RE: Spirit and Intent Request, Case # 94-384-XA, Sol Levinson Funeral Home, 10 Mt. Wilson Lane, 3rd Election District

Re: Spirit and Intent Request
Sol Levinson Funeral Home
10 Mt. Wilson Lane
CMR No. 2005030

Site & Grading Plan

LEVINSON FUNERAL HOME

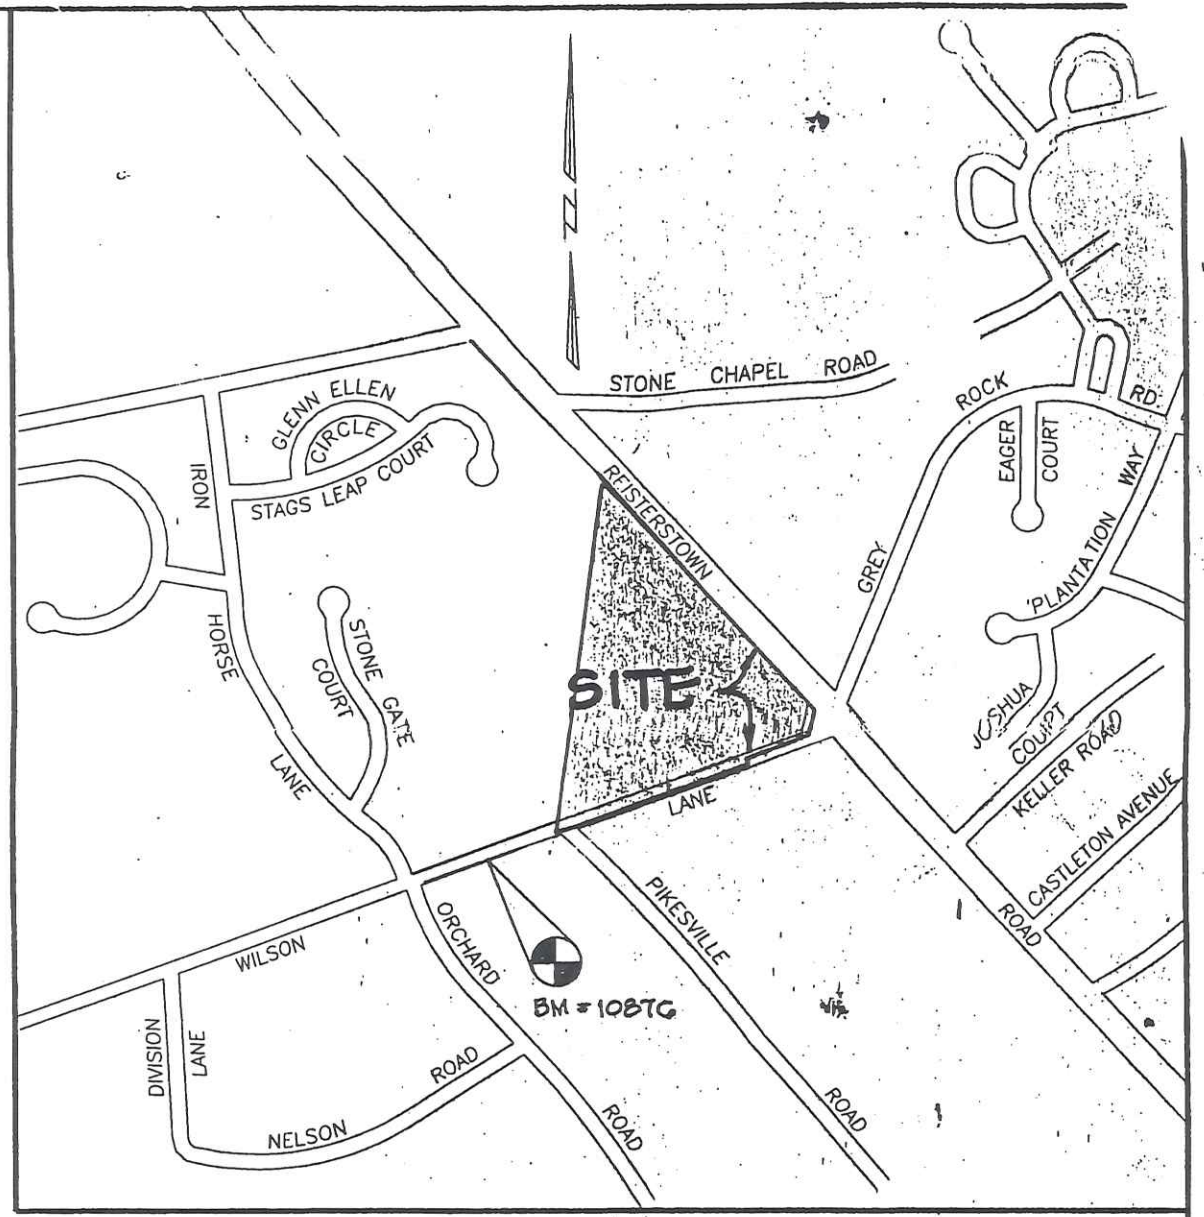
That case was a Special Exception approval to construct a funeral home as well as a variance for an illuminated sign, of 50 square feet. The current proposal is to expand the chapel by 464 square feet. The chapel expansion will be in an area now occupied by a carport. A second carport will be expanded to replace it. The proposed expansion is approximately two percent (2%) of the total building area. No other changes are proposed.

The existing parking lot provides 242 spaces and the current parking requirement is 238 spaces. The proposed expansion will add four (4) spaces to the parking requirement, which can be accommodated on the existing lot.

1. After consultation with Carl Richards, Zoning Review Supervisor, the proposed modifications to the site plan in Case # 94-384-XA, specifically the 464 square foot expansion of the chapel (area of an existing carport to be eliminated) and the expansion of the second carport are approved as being in the spirit and intent of the Baltimore County Zoning Regulations (BCZR), subject to any restrictions contained in the Zoning Commissioner's order.
2. A copy of your request letter, this response and a signed red-lined plan will be recorded and made a permanent part of the zoning case file.
3. A verbatim copy of this response must be affixed to your building permit site plan prior to building permit application.
4. This approval is for zoning only, and you will be required to comply with all other County and State regulations relative to this property.

*** ALTERNATE CRG PLAN FOR FUNERAL ESTABLISHMENT**

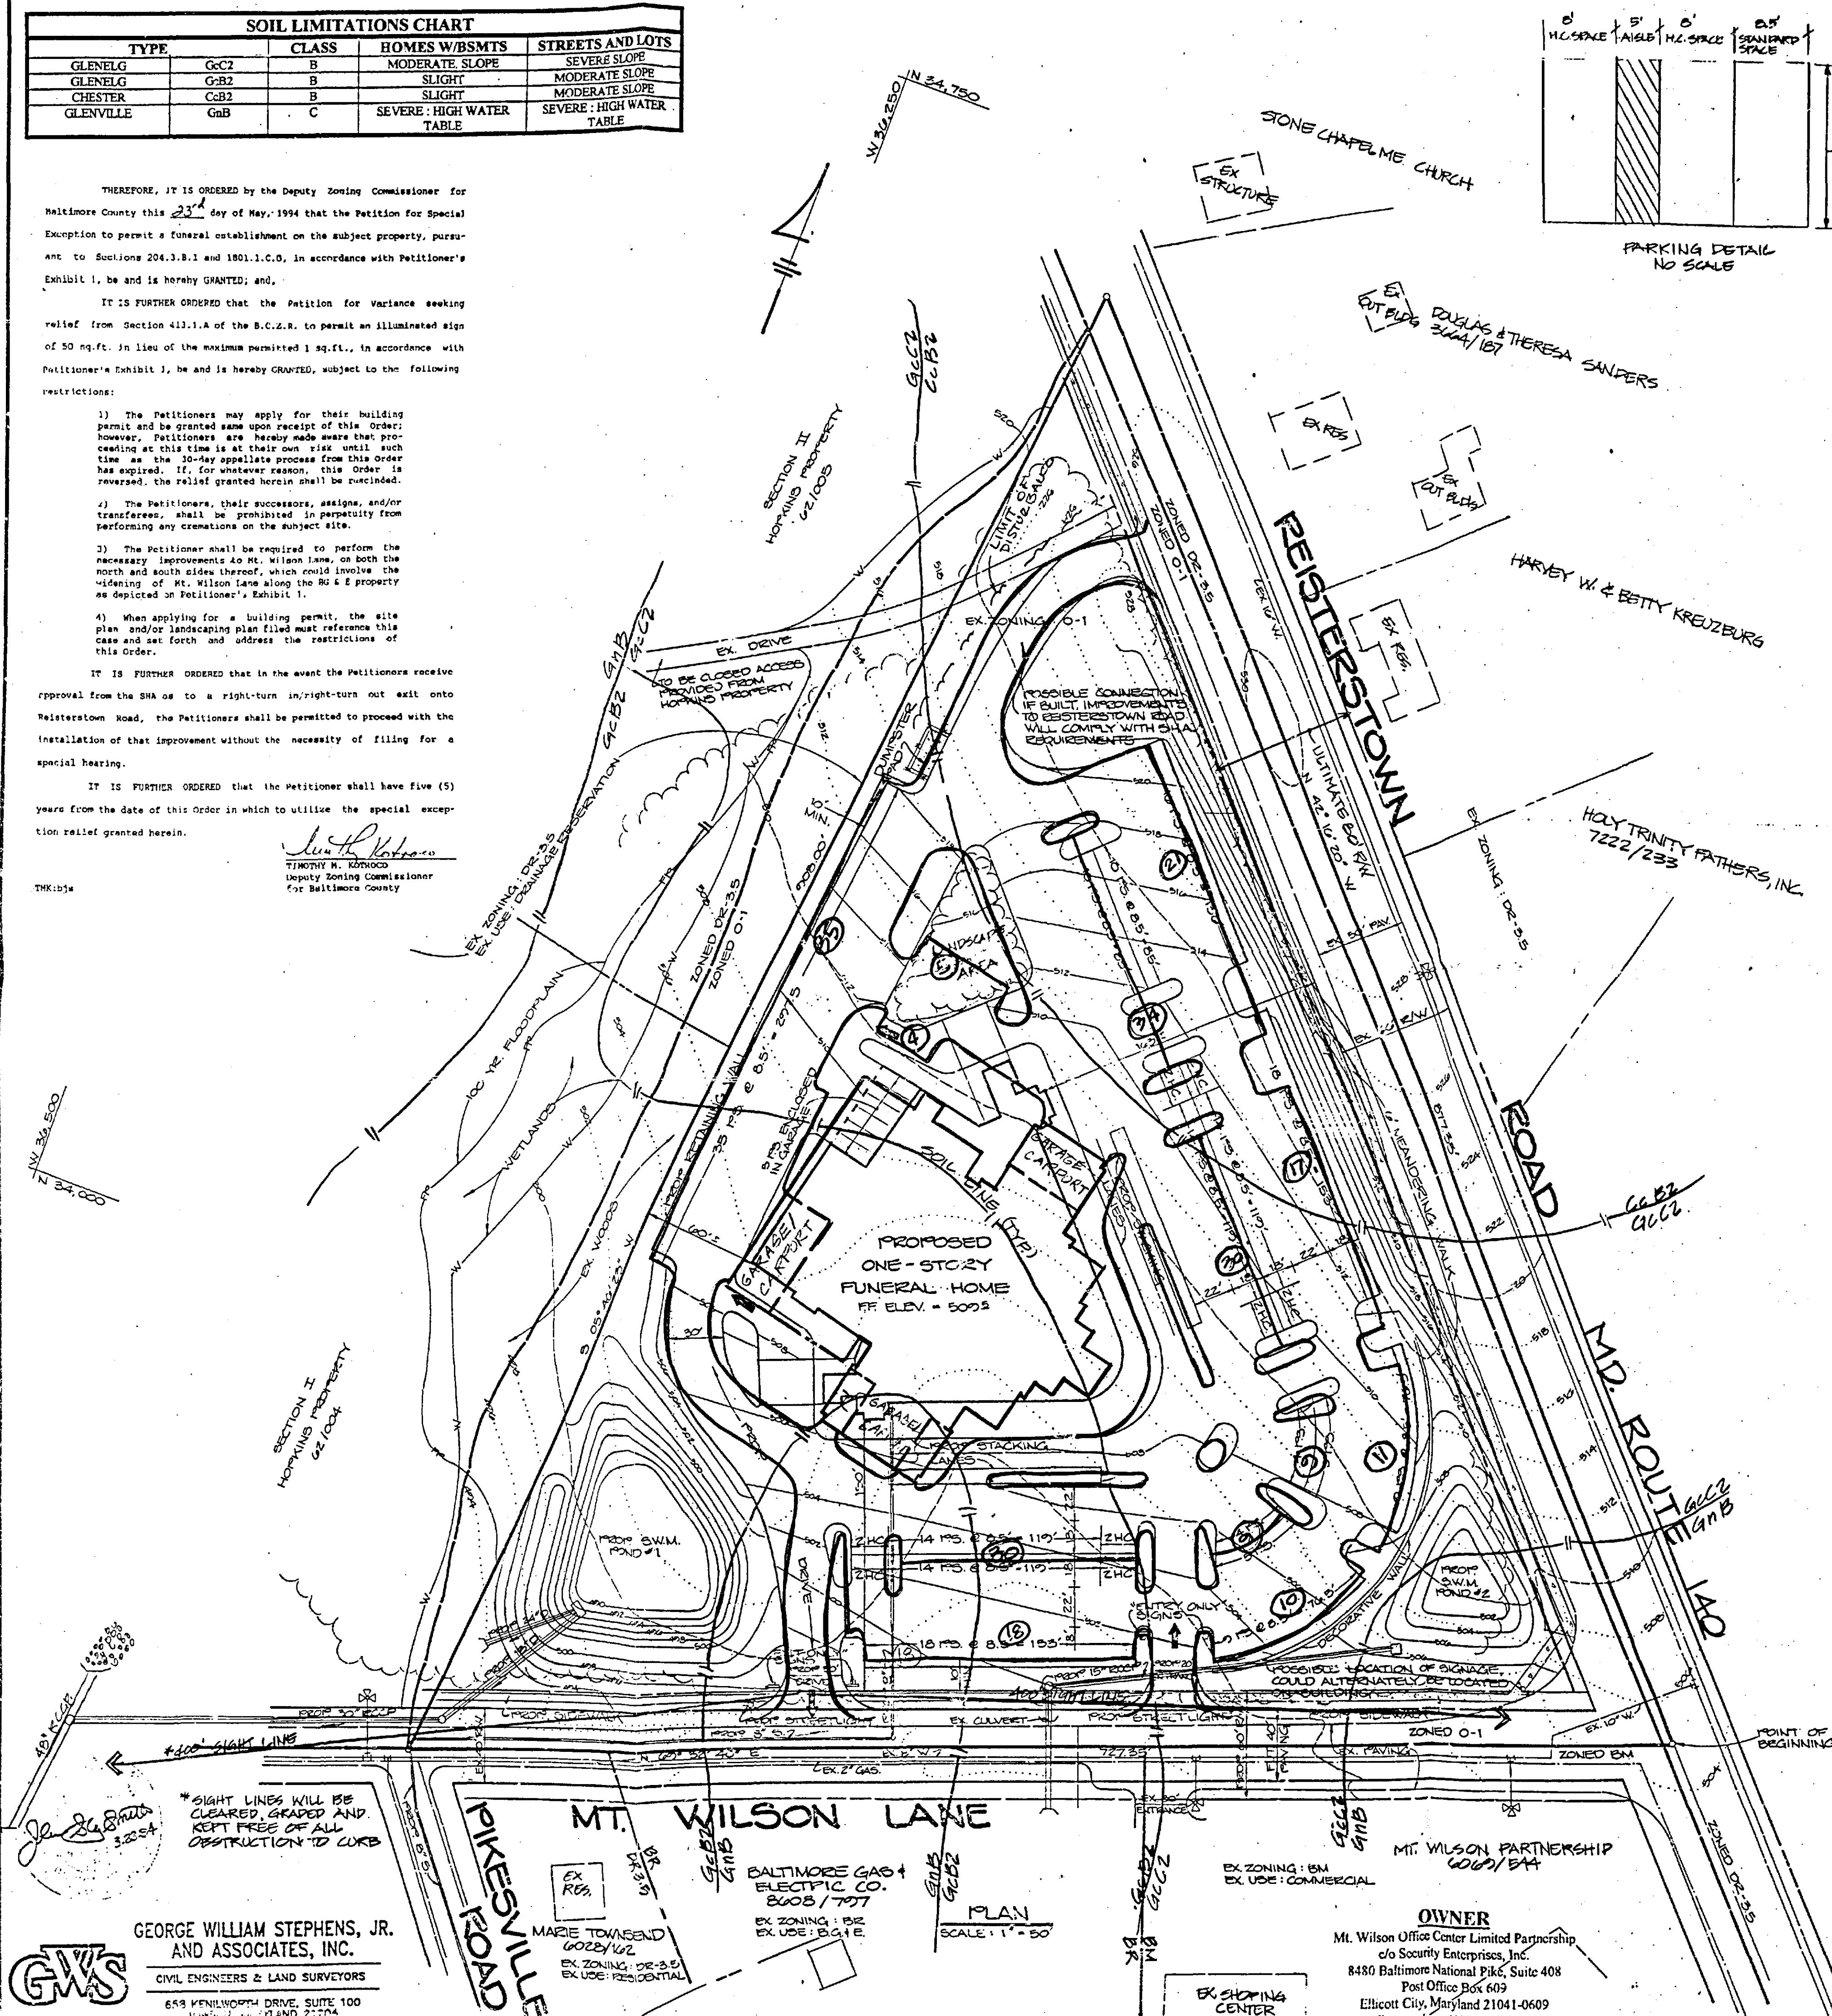
The purpose of this letter is to request your confirmation that the enclosed red-lined copy of the refined Alternates CRG Plan, which was granted a second refinement at yesterday's DRC meeting, is within the spirit and intent of the Deputy Zoning Commissioner's Order in the above-referenced case, dated May 23, 1994.

Due to the minor nature of the changes, it is respectfully submitted that the enclosed red-lined plan be considered within the spirit and intent of the Deputy Zoning Commissioner's Order in Case No. 94-384-XA, a copy of which is enclosed for your review. A check in the amount of \$40.00 has also been enclosed to cover the filing fee for this confirmation. We thank you for your prompt assistance.

Please be advised that the second refined CRG plan is within the spirit and intent of case #94-384-XA. All other zoning issues must be complied with at the time of building permit application.
